STATE OF MAINE  
DEPARTMENT OF TRANSPORTATION  
16 STATE HOUSE STATION  
AUGUSTA, MAINE 04333-0016

December 19, 2017  
Subject: Centre Street Connection  
Bridge Replacement & Sidewalk  
Construction  
State WINs: 018725.00 & 018725.10  
Location: **Bath**  
**Amendment No. 1**

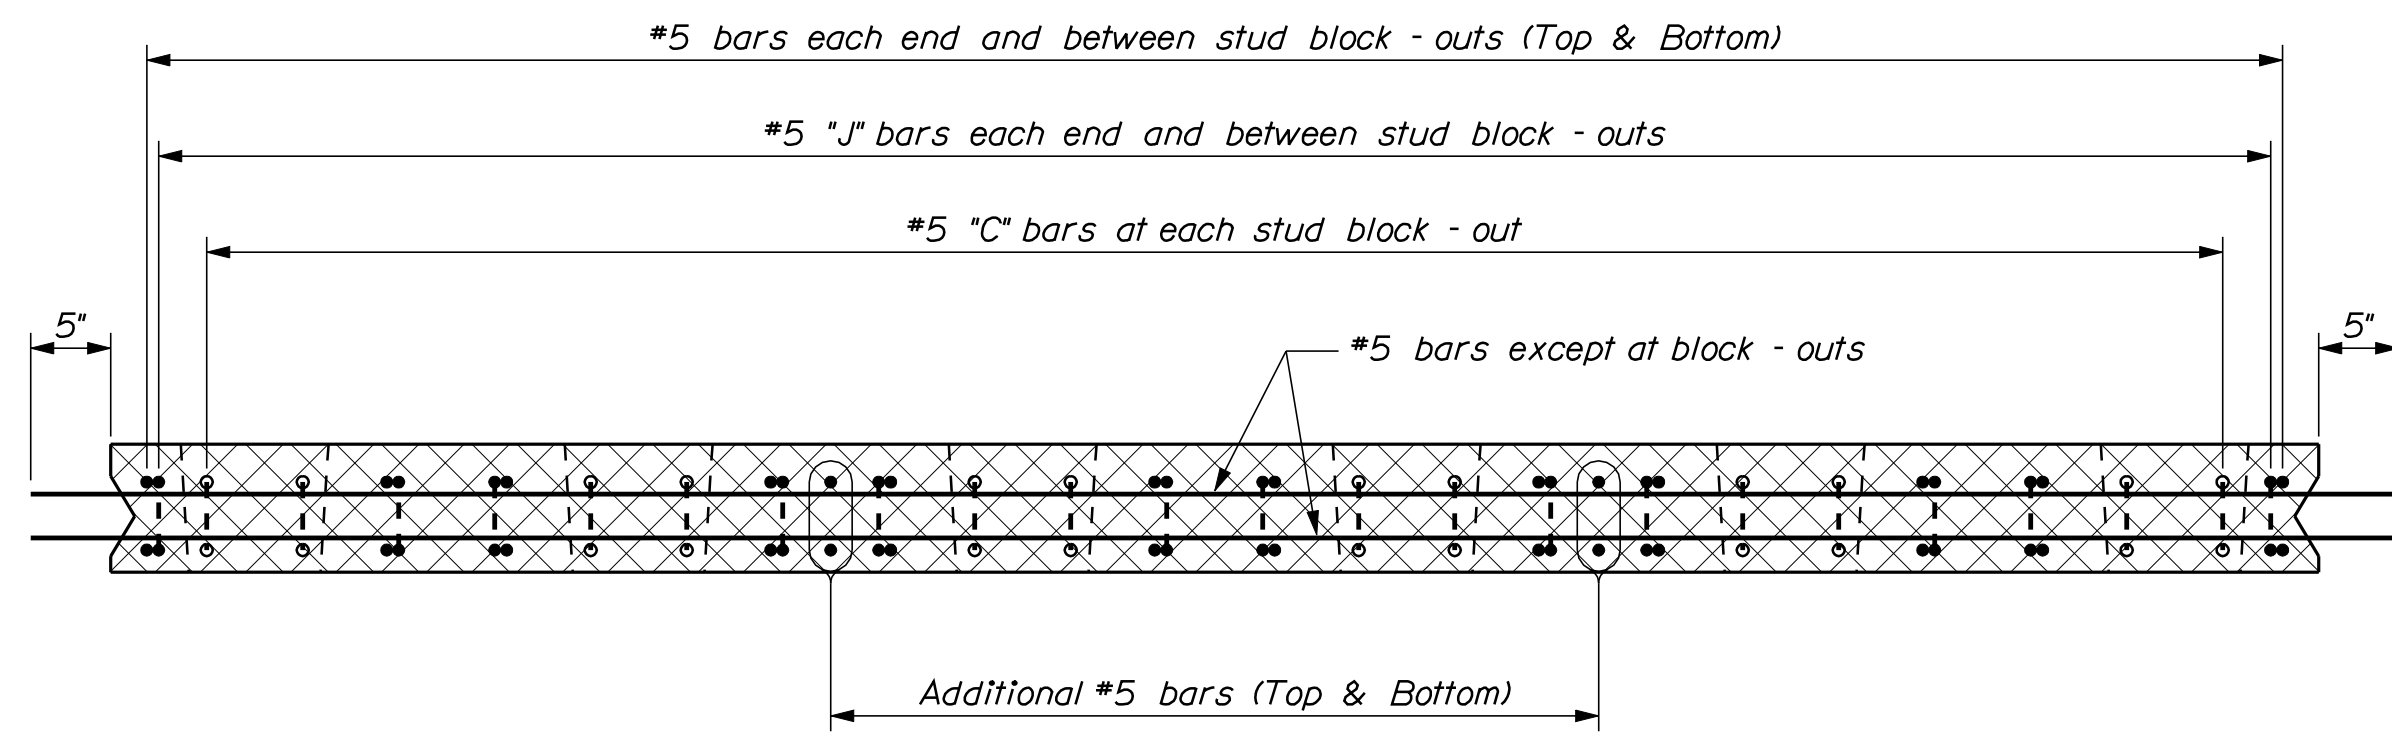
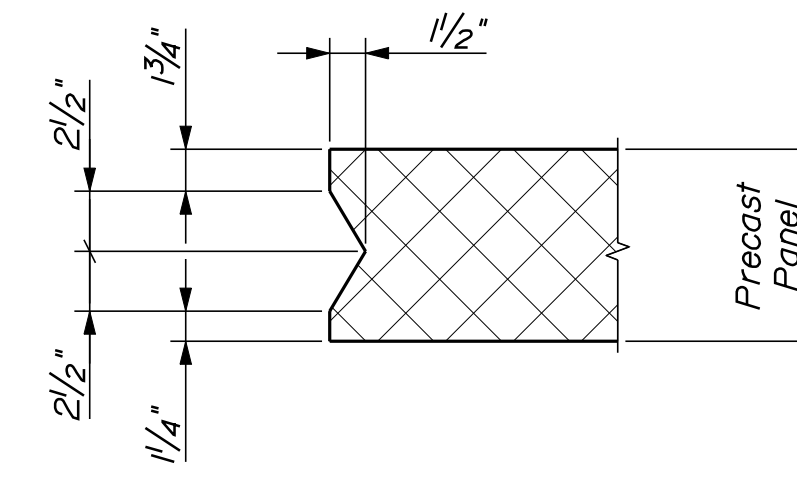
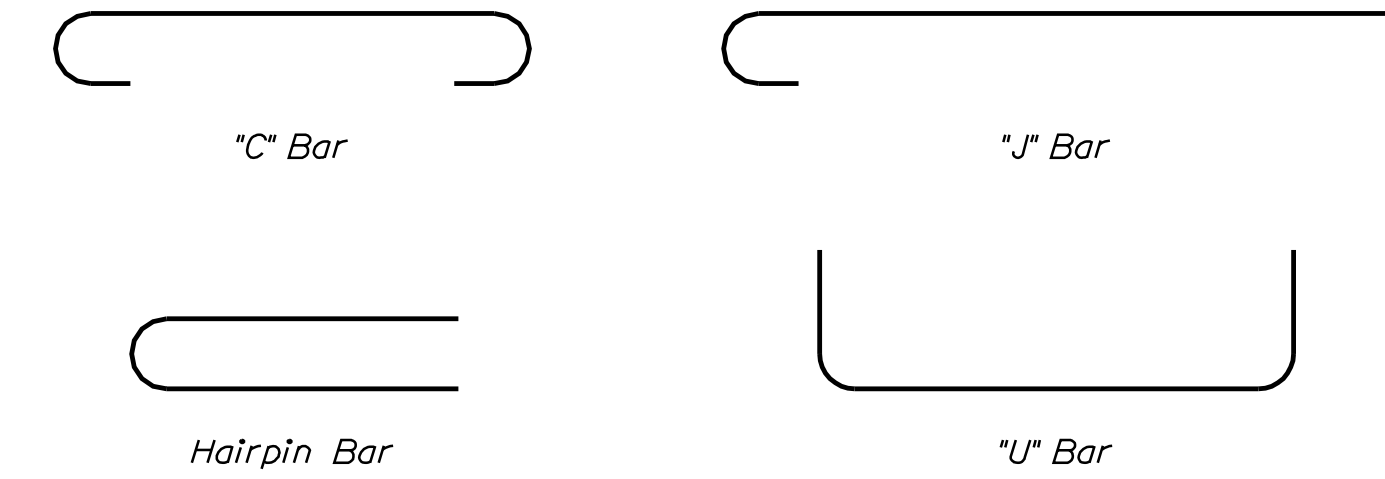
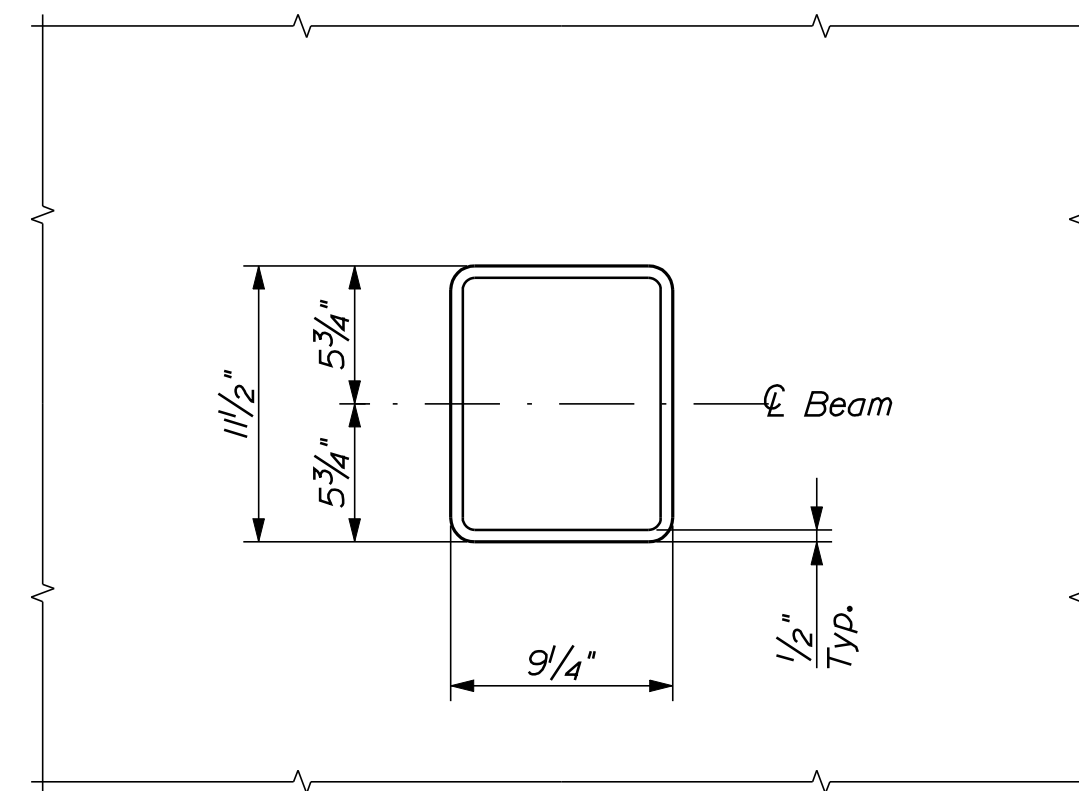
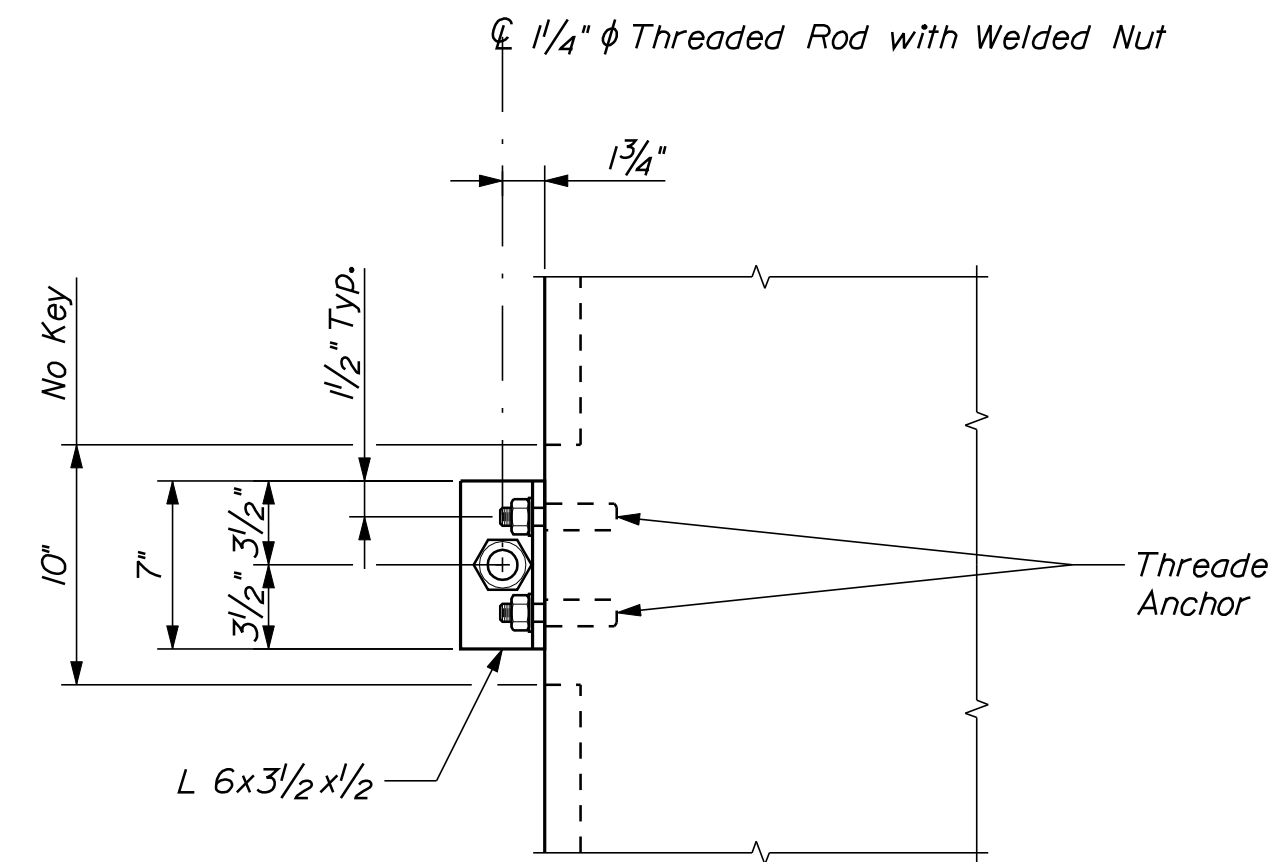
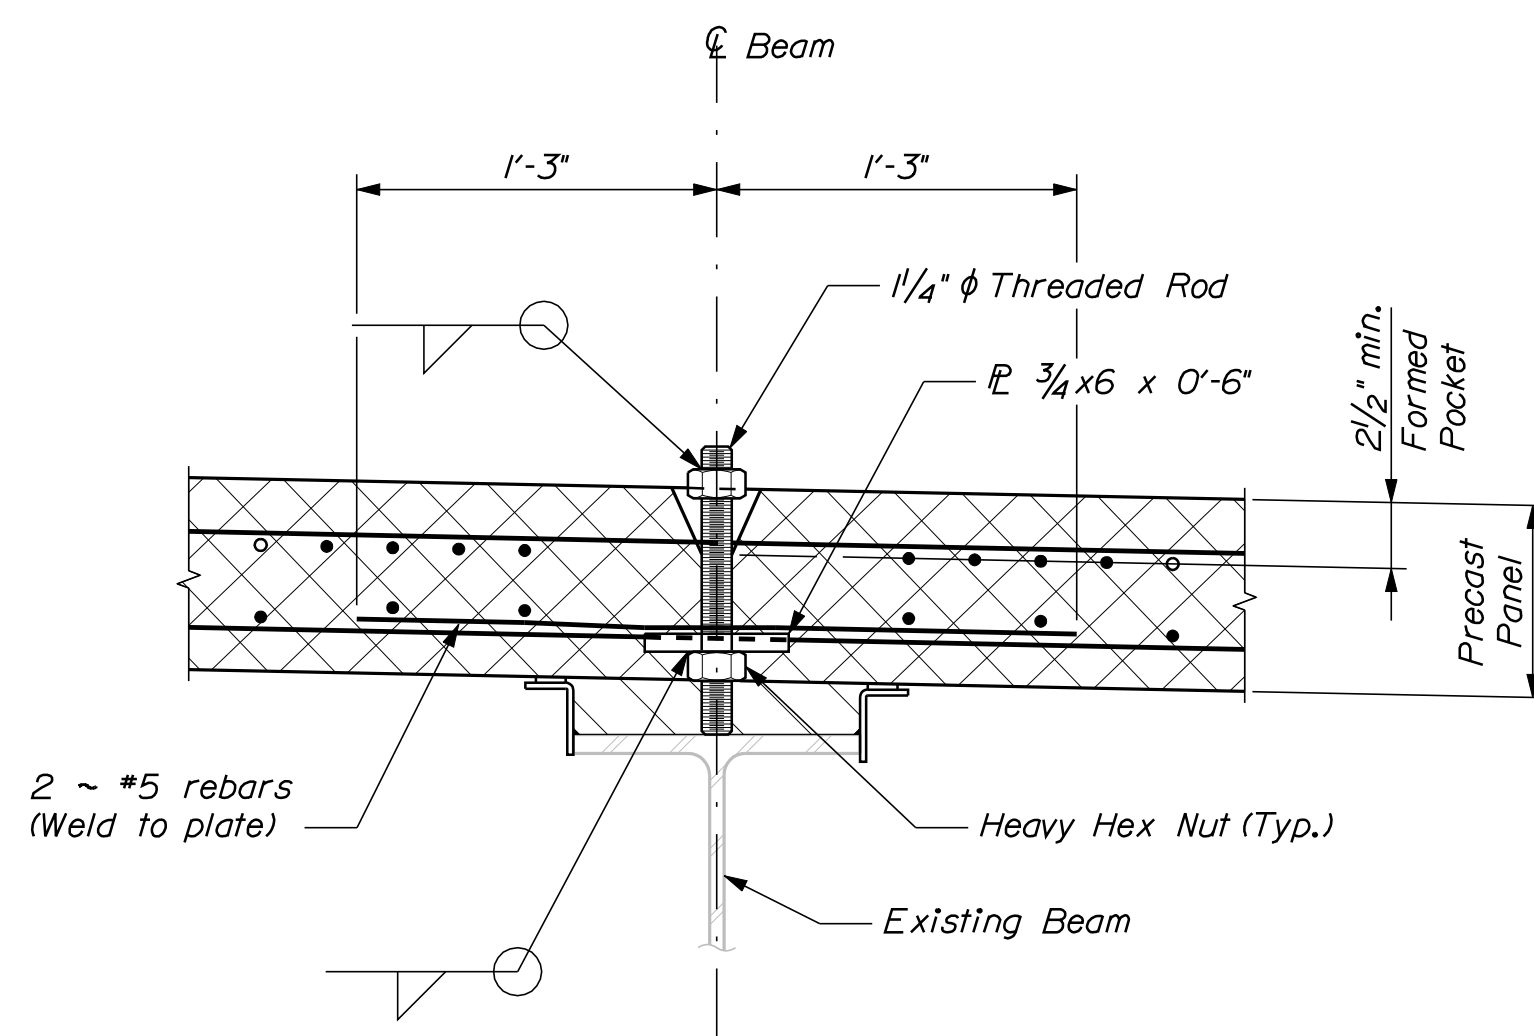
**Question:** Are stud pockets and haunches required to be placed (UHPC) before the transverse joints or some other sequence? If so, is this based on UHPC strength gain in the haunches and what strength is required?

**Response:** Stud pockets and haunches shall be placed prior to transverse and longitudinal panel joints. Please see revised sheet 39 for clarification. UHPC placements shall meet the requirements of Standard Specification Subsection 502.09 D. Removal of Forms and False work, Special Provision 502 – Ultra High Performance Concrete, and note 13 of the revised Plan sheet 39.

STATE OF MAINE DEPARTMENT OF TRANSPORTATION		STP-1872(500)		WIN BRIDGE NO. 6142 18725.00 & 18725.10 BRIDGE PLANS	
CENTRE STREET CONNECTION U.S. ROUTE 1		SAGADAHOC COUNTY		BATH	
REINFORCING		STEEL SCHEDULE		SHEET NUMBER	
49				OF 53

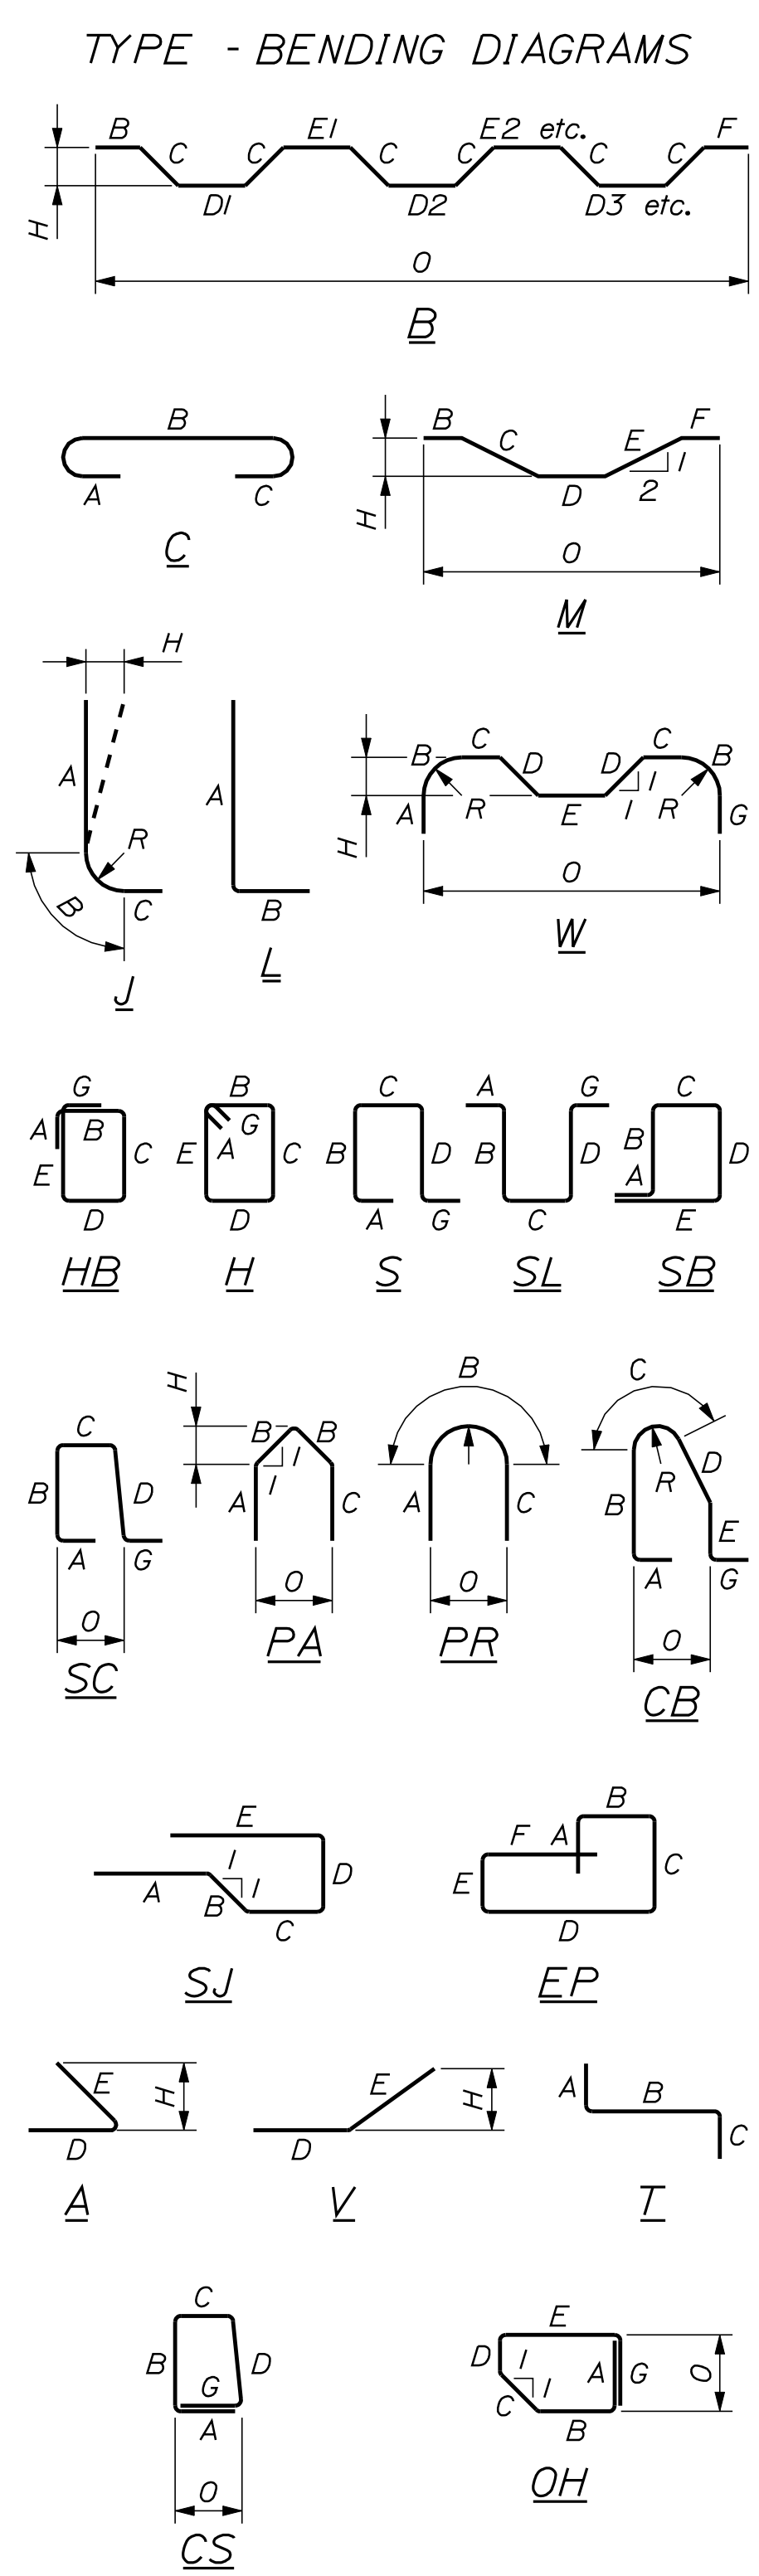
**Question:** Where is reinforcing for UHPC placements paid for?

**Response:** The reinforcement in the UHPC placements shall be paid for under items 503.12 & 503.13. Please see revised sheets 2 and 49 for clarification.
